SUBJECT: RIVER BEND STATION, UNIT 1, AMENDMENT NO. 12 TO FACILITY  
OPERATING LICENSE NO. NPF-47 (TAC NO. 65881)

Amendment No. 12  
License No. NPF-47

SAFETY EVALUATION BY THE OFFICE OF NUCLEAR REACTOR REGULATION  
SUPPORTING AMENDMENT NO. 12 TO FACILITY OPERATING LICENSE NO. NPF-47

**FIGURE 3.2.1-5**

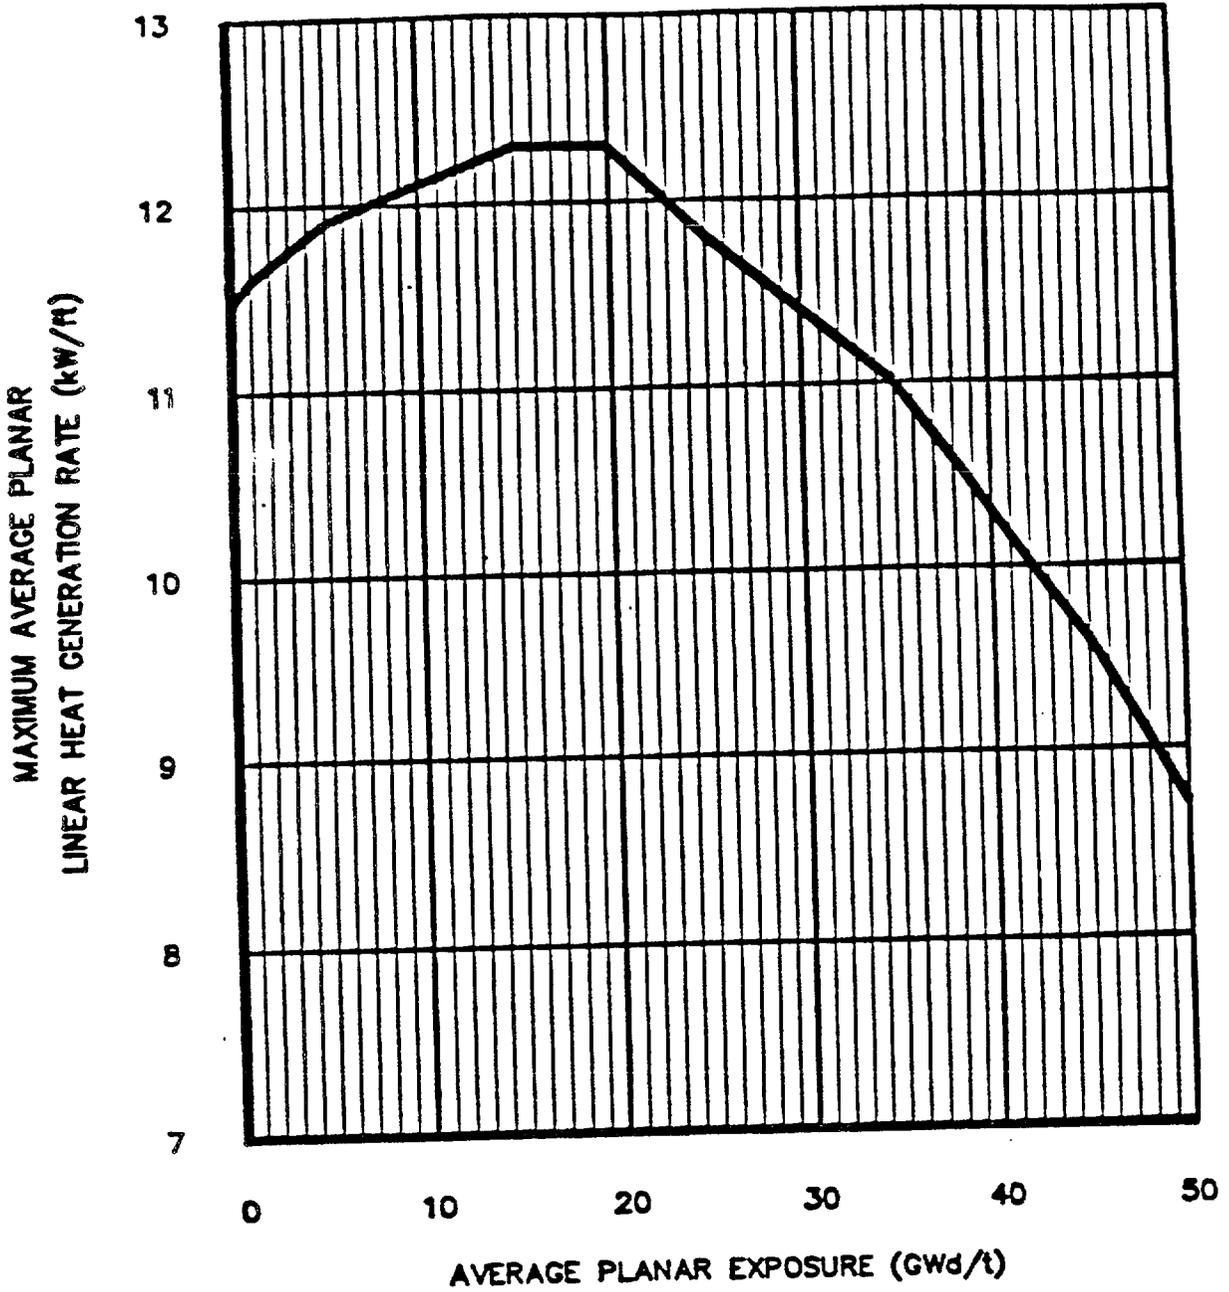
The licensee requests to be allowed to use GE fuel types BP8SRB299 and BP8SRB305 which have slightly higher enrichment than the present fuel types and will allow higher burnup. The core loading is the conventional new assembly scatter pattern, with low reactivity (old) assemblies located on the periphery. The new assembly types are not described in GESTAR II (Ref. 3).

The new fuel for Cycle 2 is the GE fuel designated BP8SRB299 and BP8SRB305. This fuel is in the same class with approved designs but not for the enrichments used here. The specific description of this fuel is presented in Reference 4. This fuel description is acceptable.

For Cycle 2 operation, appropriate Maximum Average Planar Linear Heat Generation Rates (MAPLHGR) have been determined by approved thermal, mechanical and Loss-of-Coolant Accident (LOCA) analyses calculations. The most limiting MAPLHGR as a function of burnup for the new core loading are presented in the proposed Technical Specifications (Ref. 1) for the old and the new fuel types present in Cycle 2.

3.2.1 All AVERAGE PLANAR LINEAR HEAT GENERATION RATES (APLHGRs) for each type of fuel as a function of AVERAGE PLANAR EXPOSURE shall not exceed the limits shown in Figures 3.2.1-1, 3.2.1-2, 3.2.1-3, 3.2.1-4, 3.2.1-5, and 3.2.1-6.
